Access Compliance Report Public Rights-of-Way (Pedestrian Signals)

Main Street: GILBERT_ST Cross Street: W BALL_RD Location: NW

ADA ID: SGRK210927172119 Signal Type: One Push Button-Non APS Overall Compliance: No Severity Scores: BTN 1: 35 BTN 2: N/A No BTN: N/A

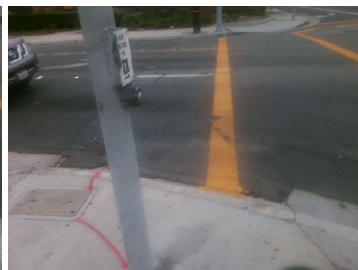
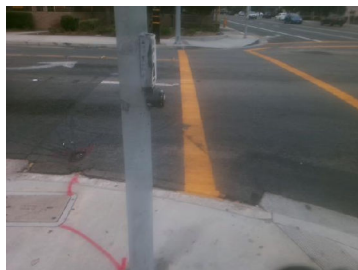
OC Std/PROW: R404.2, MUTCD 4e.08

Possible Solutions: Replace Signal Push Button With APS Button. Remove and Replace Clear Space.
